Form 3160-5
(June 2019)

SUNDRY NOTICES AND REPORTS ON WELLS
Do not use this form for proposals to drill or to re-enter an abandoned well. Use Form 3160-3 (APD) for such proposals.

Tweety Bird 17 Fed Com 305H (FKA 501H) API #: 30-025-51767

EOG respectfully requests an amendment to our approved APD for this well to reflect the following changes:

WELL LOCATION AND ACREAGE DEDICATION PLAT

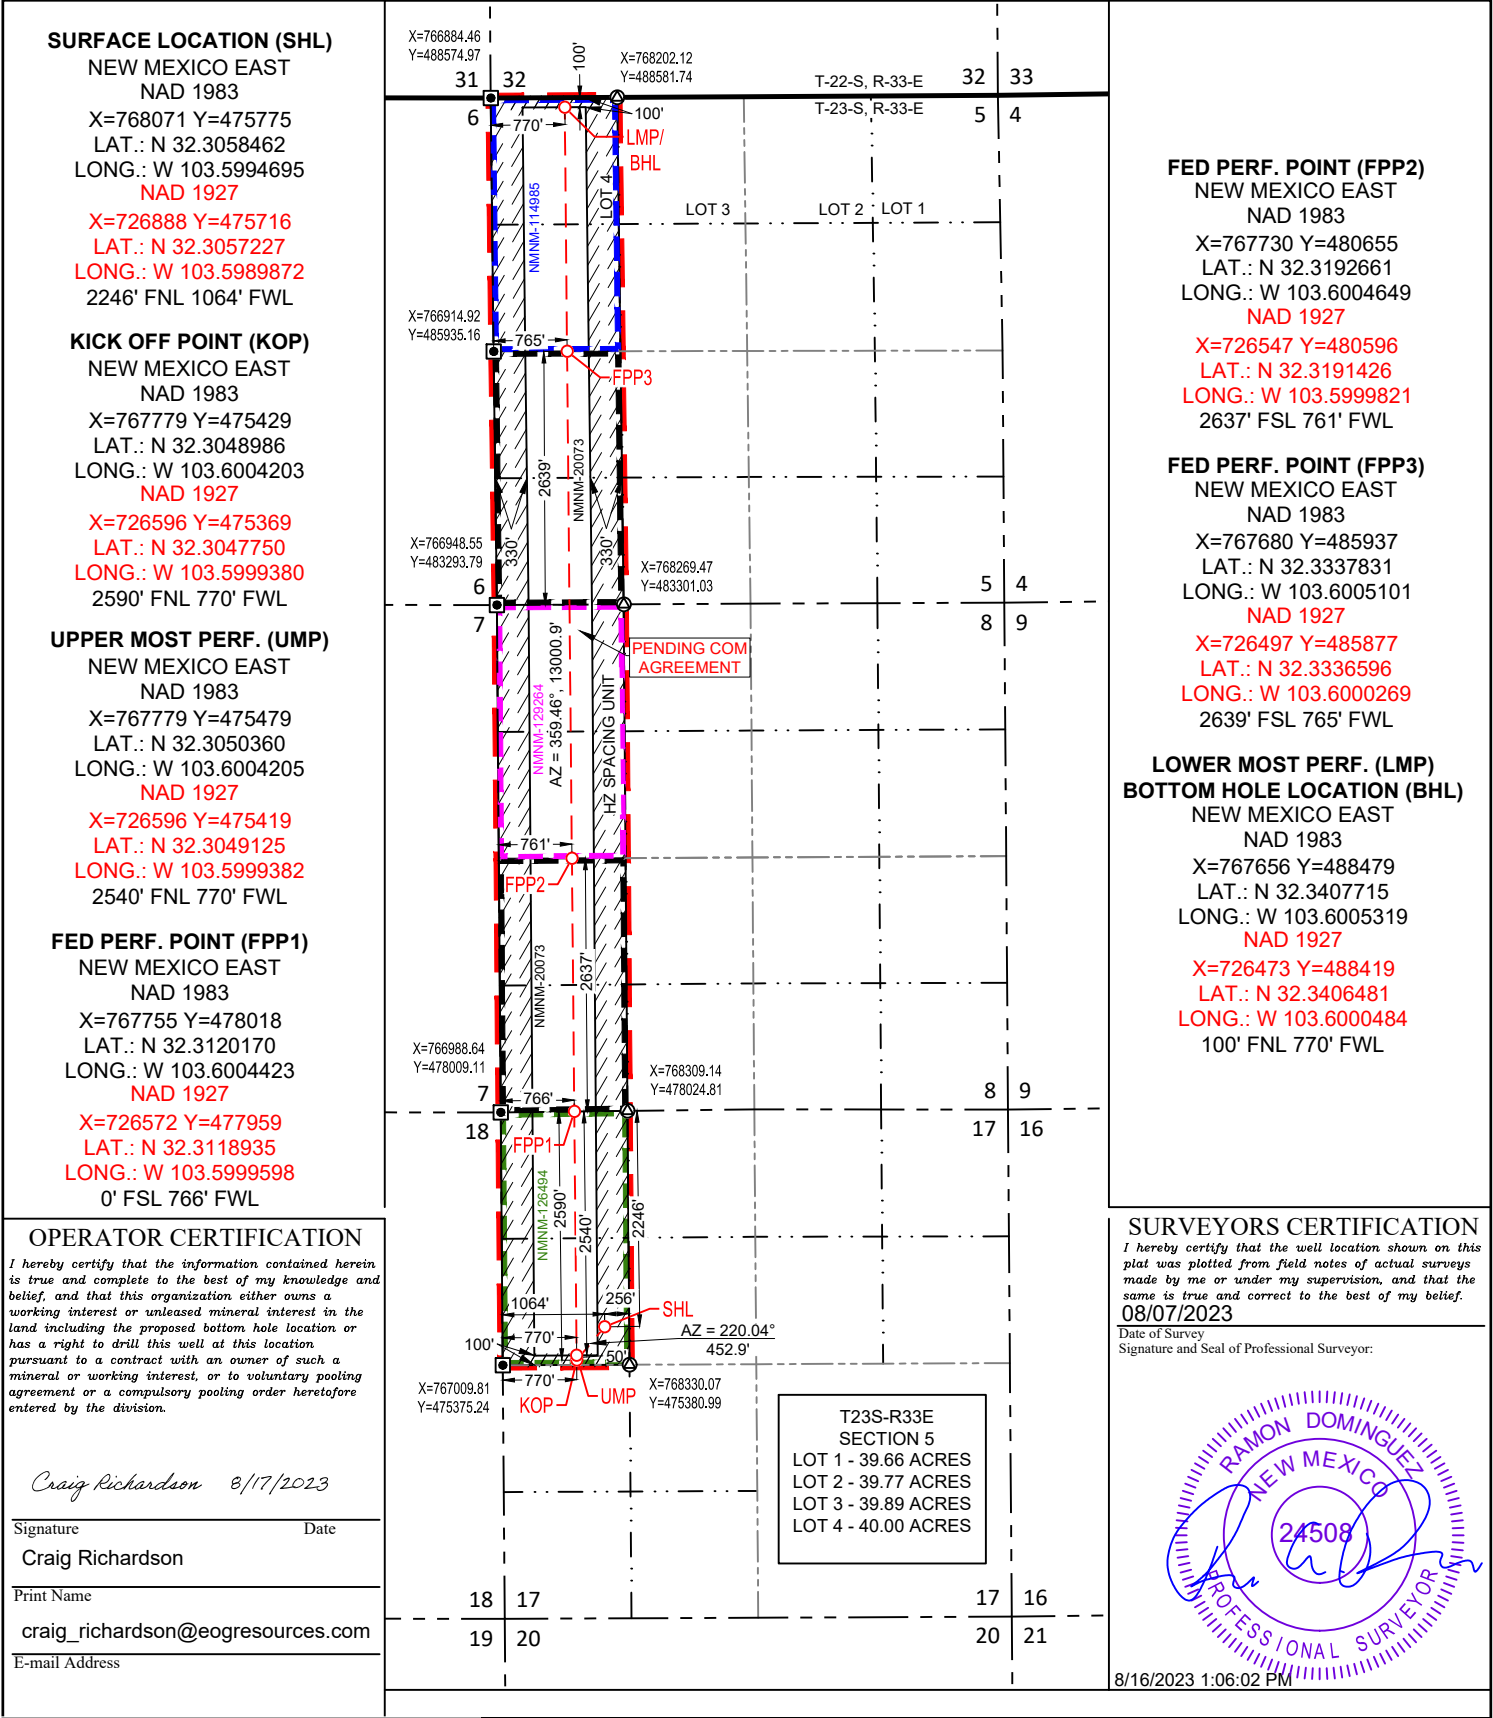
Change BHL from T-23-S, R-33-E, Sec 5, 100' FNL, 330' FWL, Lea Co., NM, to T-23-S, R-33-E, Sec 5, 100' FNL, 770' FWL, Lea Co., N.M.

UL or lot no.	Section	Township	Range	Lot Idn	Feet from the	North/South line	Feet from the	East/West line	County
4	5	23-S	33-E	-	100'	NORTH	770'	WEST	LEA

Revised Wellbore A:

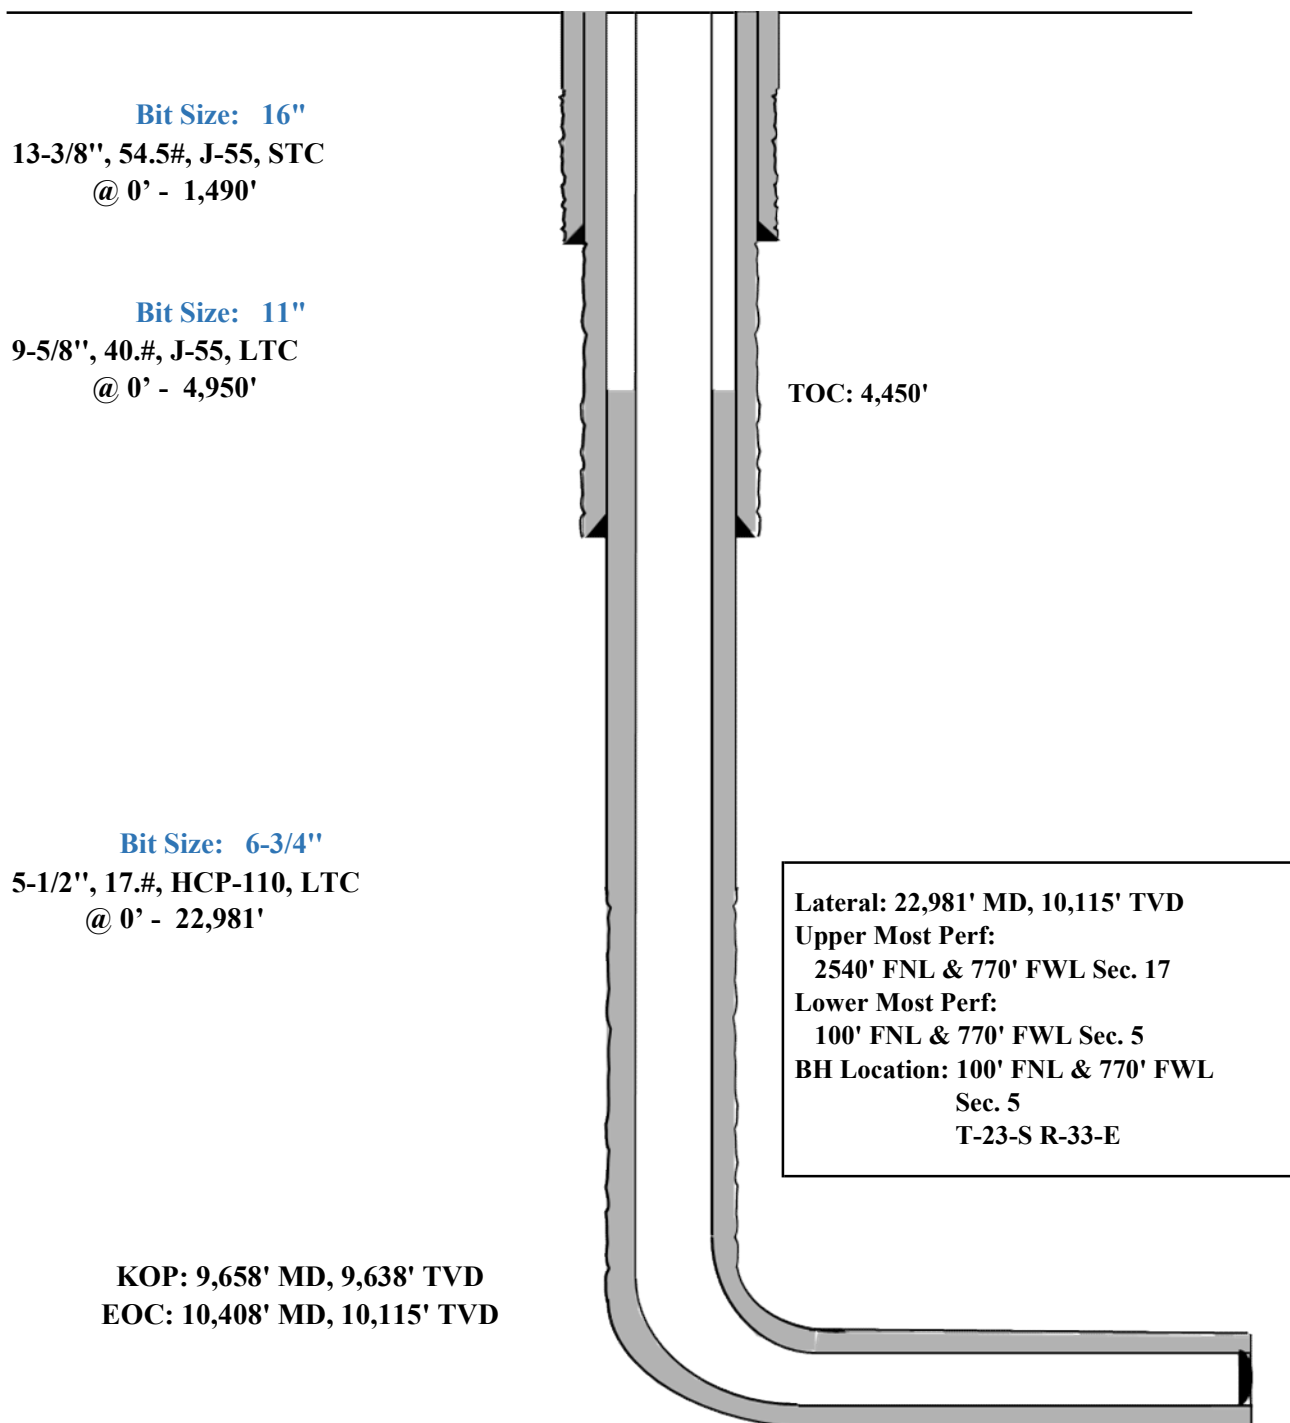
Update casing and cement program to current design.

Proposed 11" Hole with 9.625" 40# J55/HCK55 LTC Casing

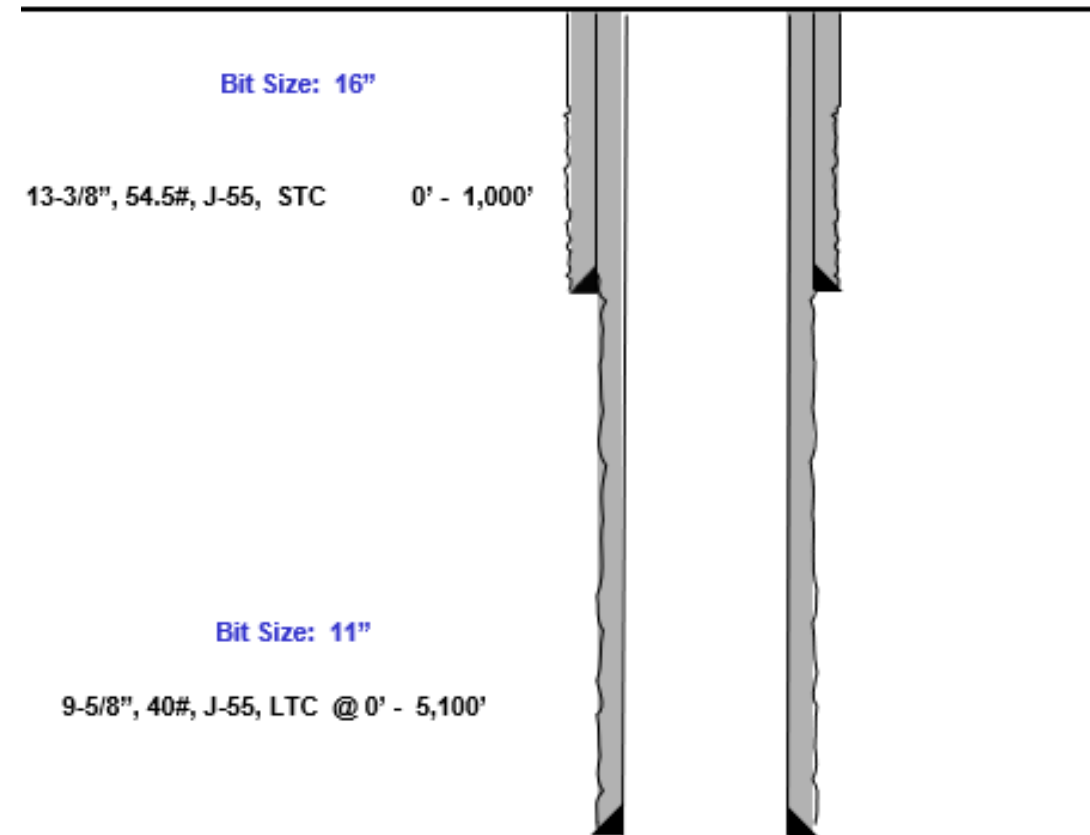
EOG request permission to allow deviation from the 0.422" annulus clearance requirement for the intermediate (salt) section from Onshore Order #2 under the following conditions:

- 11" Bit + 0.52" Average hole enlargement = 11.52" Hole Size
 - 0.9475" Clearance to casing OD
